Attachment B

Revise the Technical Specification pages as follows:

### 5.4 Fuel Storage Specification

The purpose of this amendment is to allow storage of Westinghouse OFA fuel with a nominal enrichment of up to 5.0 w/o U-235 in the new and spent fuel storage racks.

Figure 5.4-2  
Fuel Assembly Burnup Limits in Region 2

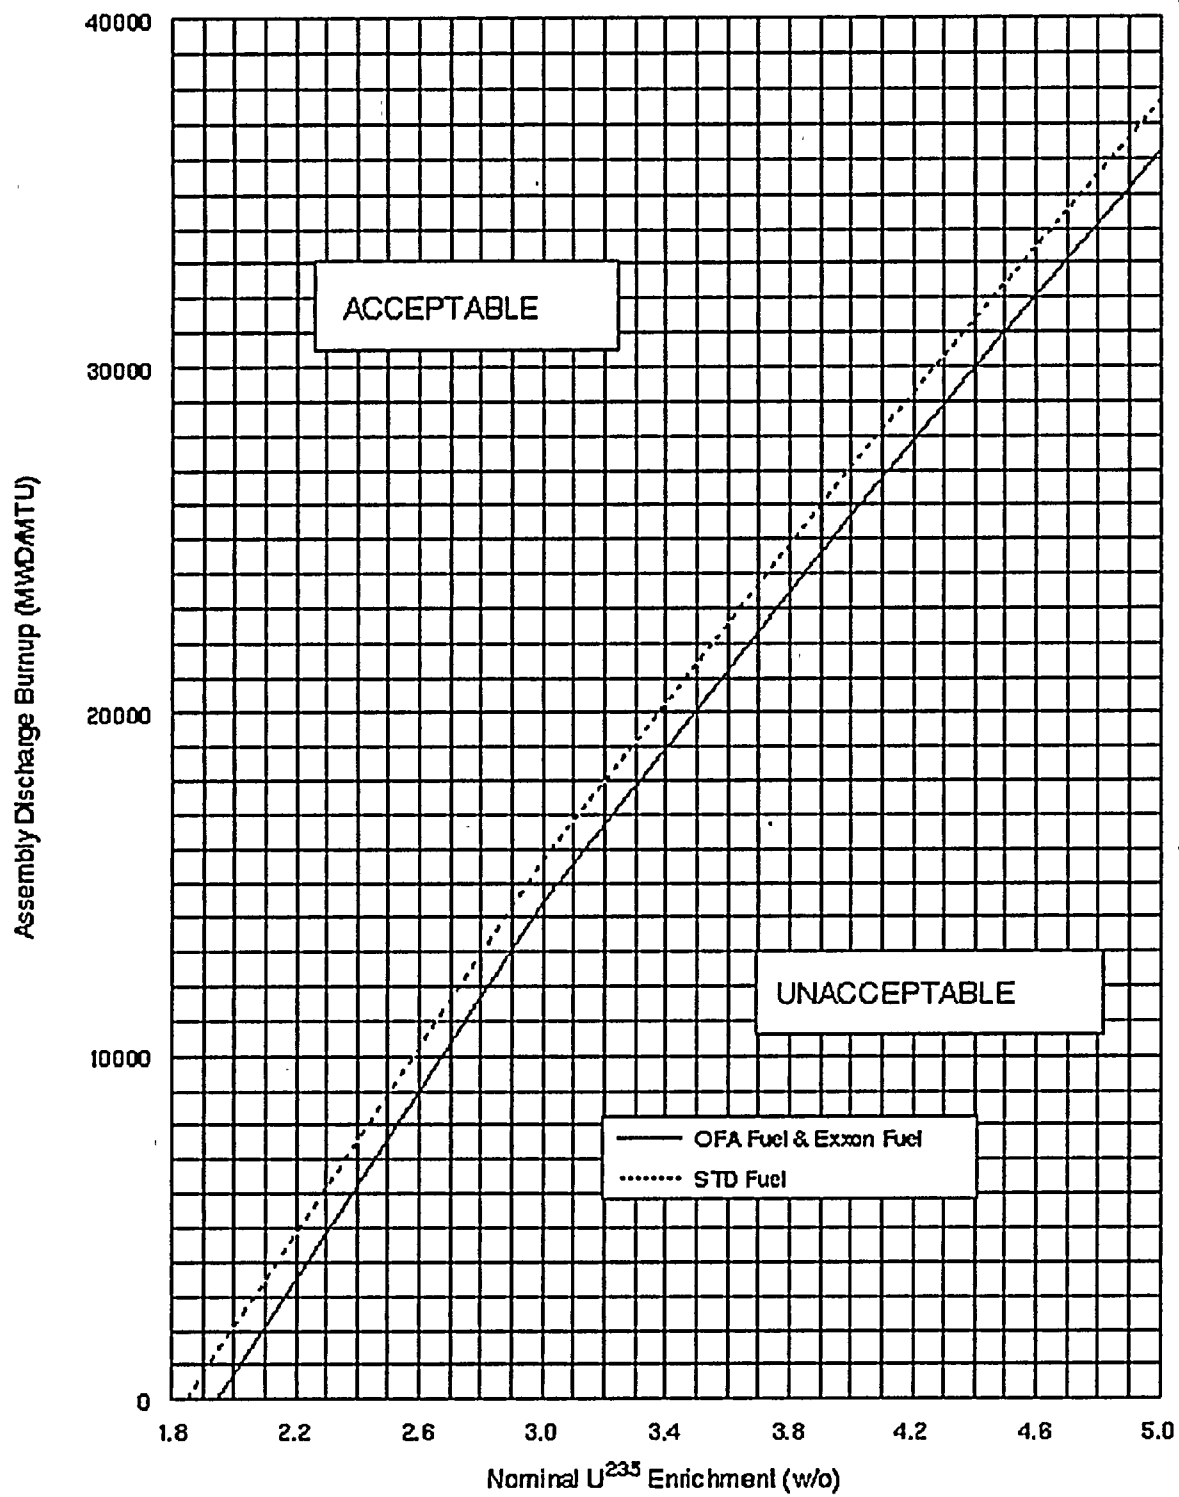
The two curves of Figure 5.4-2 divide the fuel assembly designs into two groups. The first group is all fuel except Exxon fuel delivered prior to January 1, 1984, which incorporates all Westinghouse HIPAR designs used at Ginna.<sup>4</sup> The second curve is for all Exxon fuel, as well as the Westinghouse Optimized Fuel assembly design delivered to Ginna beginning in February 1984.<sup>3</sup>

The calculations of fuel assembly burnup for comparison to the curves of Figure 5.4-2 to determine the acceptability for storage in Region 2 shall be independently checked. The record of these calculations shall be kept for as long as fuel assemblies remain in the pool.

In Reference (a) RG&E submitted an engineering calculation that demonstrated that the allowable enrichment of fuel to be stored in the new and spent fuel storage racks could be increased to a nominal 5.0 w/o U-235. There were no restrictions on placement in the new fuel storage racks. Placement in Region 1 of the spent fuel storage racks requires a minimum number of integral fuel burnable absorber (IFBA) rods. Placement in Region 2 of the spent fuel storage racks requires a minimum fuel burnup. This requirement is illustrated on Figure 5.4-2 of the proposed Amendment.

- 5.4.3 In Region 2 of the spent fuel storage racks, fuel is stored in a close packed array utilizing fixed neutron poisons in each of the stored locations. For discharged fuel assemblies to be stored in Region 2, (1) 60 days must have elapsed since the core reached hot shutdown prior to discharge and (2) the combination of assembly average burnup and initial U-235 enrichment must be such that the point identified by these two parameters on Figure 5.4-2 is above the line applicable to that particular fuel assembly design, therefore assuring that  $K_{eff} \leq 0.95$ .
